TOWN OF BAY HARBOR ISLANDS
DEVELOPMENT & REVIEW COMMITTEE MEETING
THURSDAY, DECEMBER 8, 2022

Subject: Site Development Plan Application – DRC Review #3
Proposed 9 DU Multi-family Residential Complex
1055 93rd Street
Bay Harbor Islands Acct. No. SPR22-000026
MMPA Acct. No. 01-0702-1144

RE: **1055 93rd Street**
Site Plan Review Submission, Revision 2
CODE COMMENT RESPONSES

TITLE
SITE PLAN AND
ZONING INFORMATION

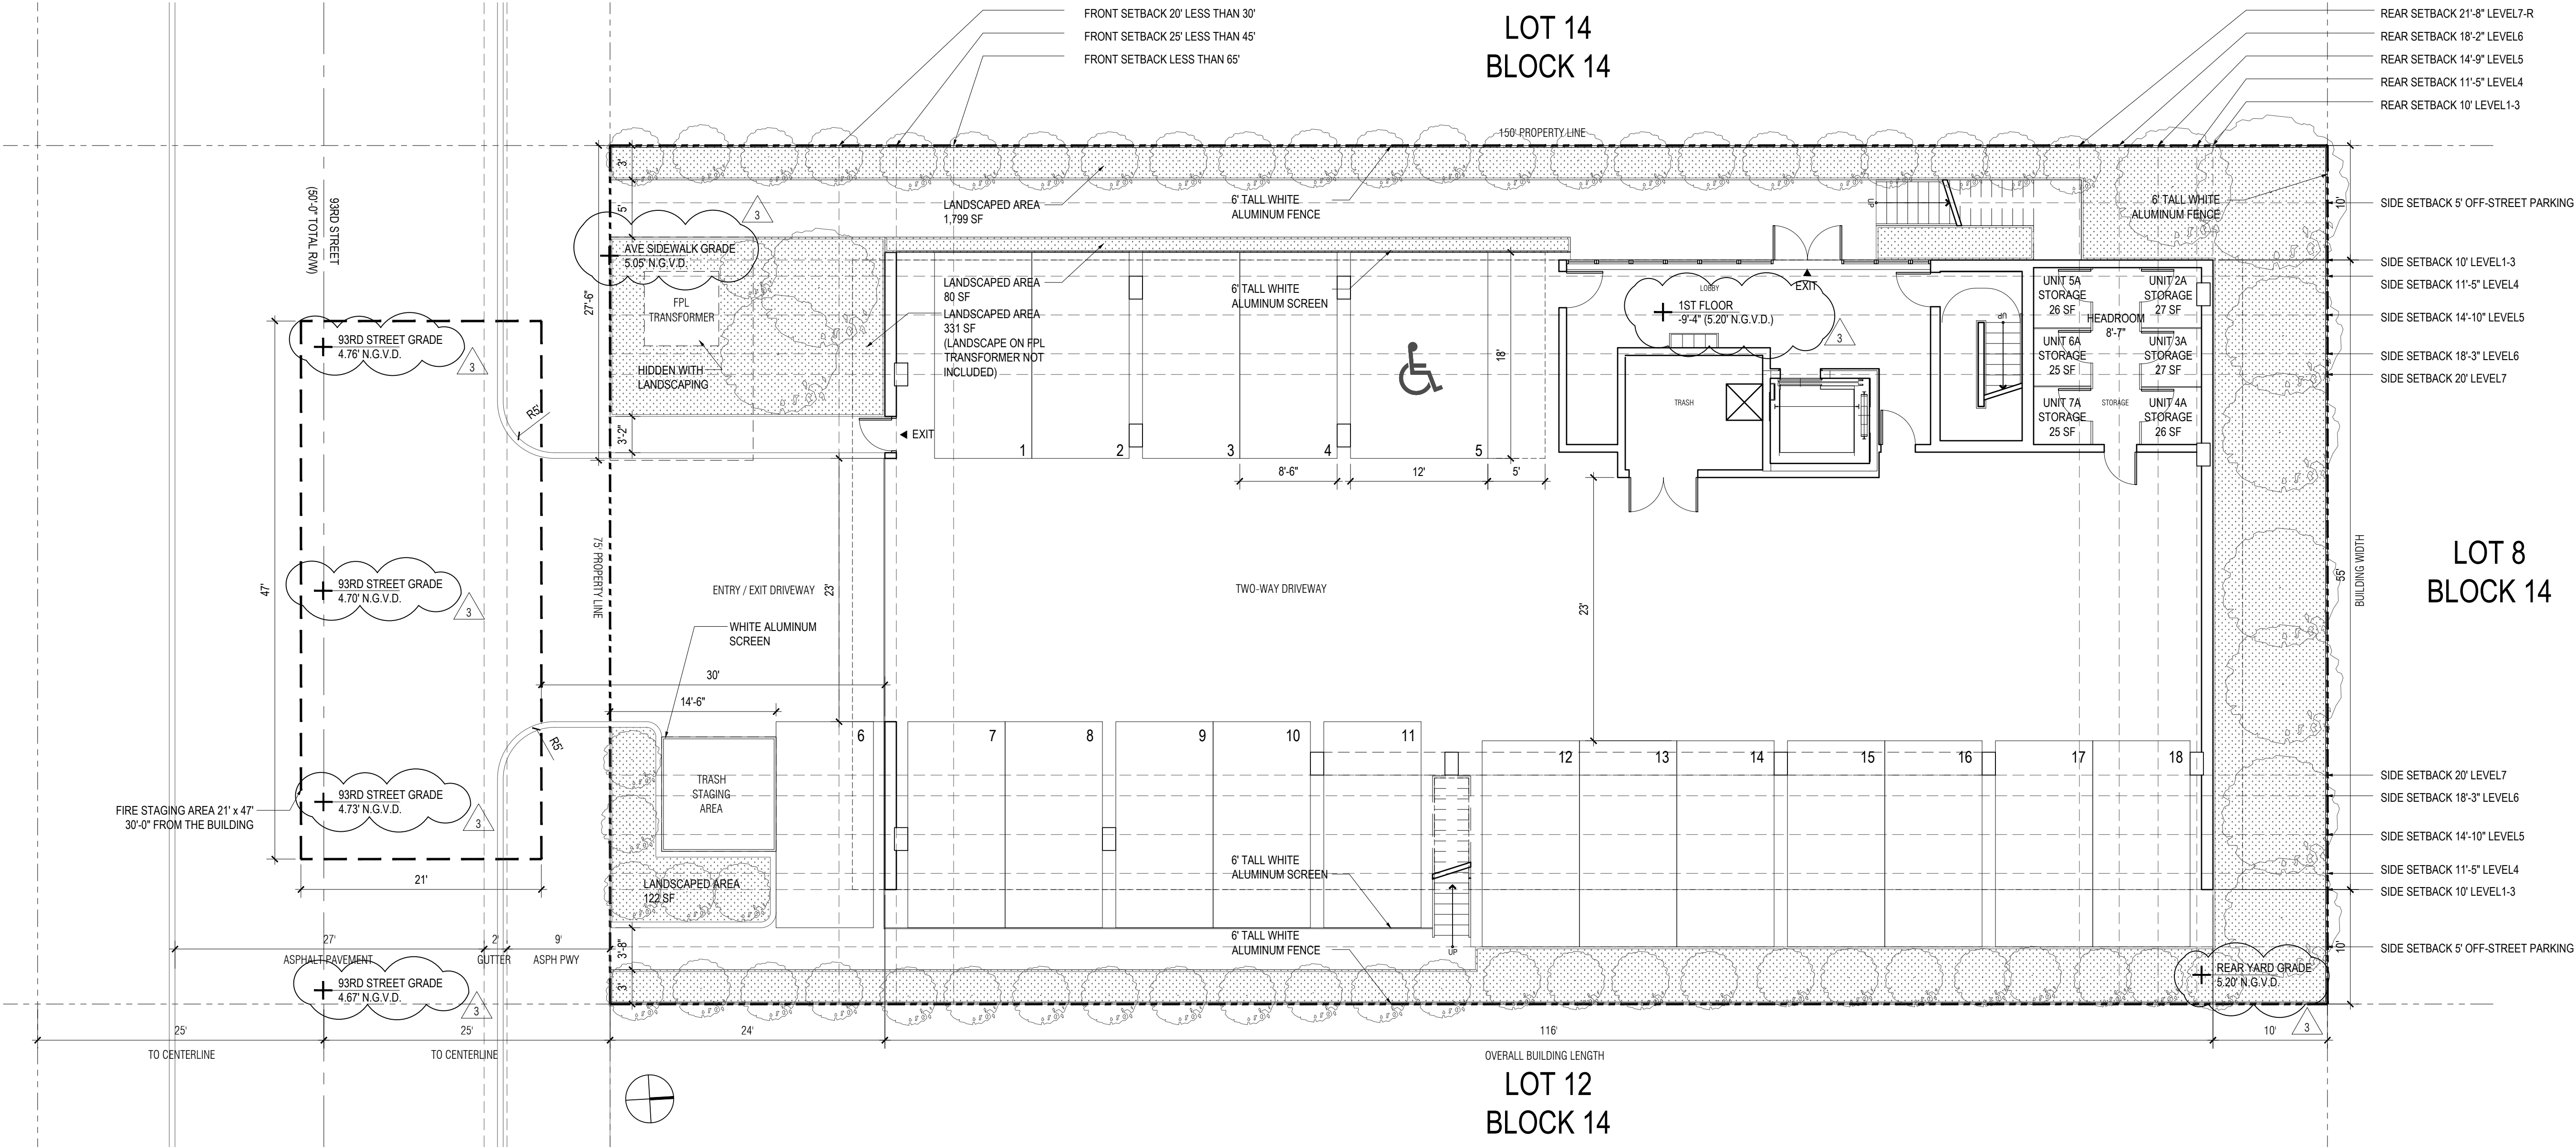
1. Show a complete flood legend (finished floor elevation, lowest elevation of equipment, flood zone, panel number, base flood elevation, highest crown of road, lowest and highest adjacent grades, etc). as per FBC 107.3.5.2 on all areas below BFE plus 1.

RESPONSE: Please refer to the new FLOOD INFORMATION and LEGEND that has been added to A-05. The site grading has been adjusted by taking the average elevation of the site as our garage finished floor elevation at the elevator lobby — 5.20' NGVD — and all other building elevations have been adjusted accordingly.
